CERTIFICATE OF APPROPRIATENESS

Property: Lot 27, Block 30, Glenbrook Valley Neighborhood Subdivision. The property includes a historic 1,863 square foot, one-story brick single-family residence and attached garage situated on a 7,438 square foot (110' x 65' x 122' x 68') interior lot.

- Remove (10) original aluminum mill-finished windows, recessed 2-over-2 horizontal divided light
- Replace with (10) Croft aluminum mill-finished windows single-hung, recessed, 1-over-1, no grille, within same window opening

SITE MAP - PROPOSED REPLACEMENT WINDOWS

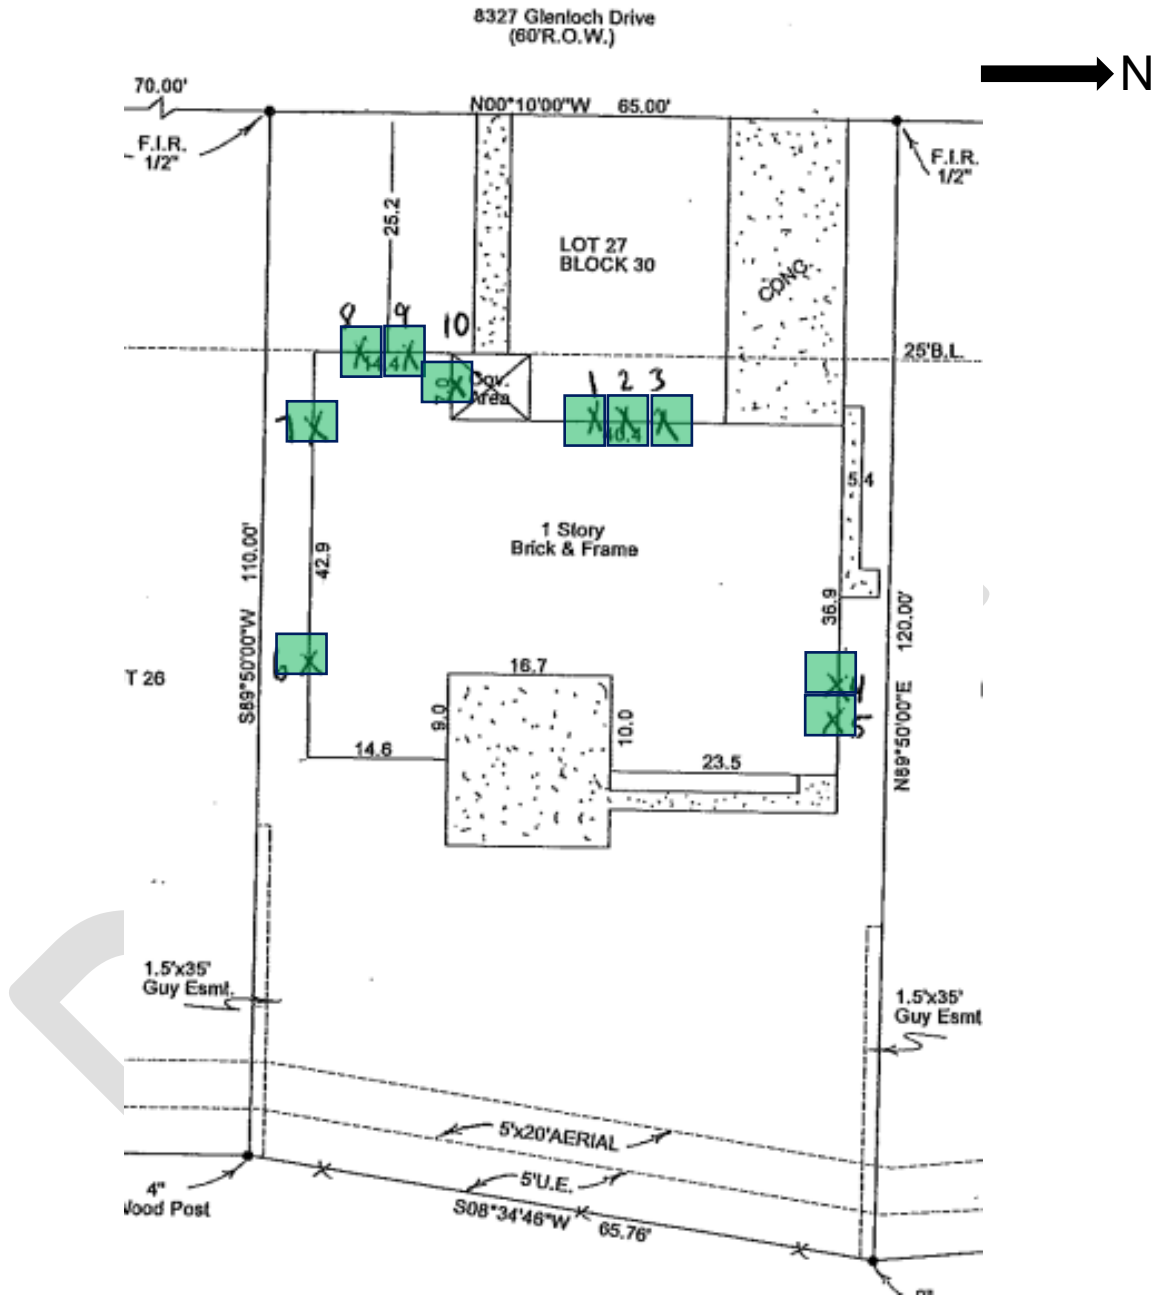
ALL NEW WINDOWS MUST BE INSET 1¾ Inches – See Attachment 1

| <input type="checkbox"/> | <input checked="" type="checkbox"/> | <input type="checkbox"/> | (9) The proposed design for any exterior alterations or addition must not destroy significant historical, architectural, archaeological, or cultural material, including but not limited to siding, windows, doors and porch elements; <i>Removal of original Aluminum Mill Finished Windows</i> |
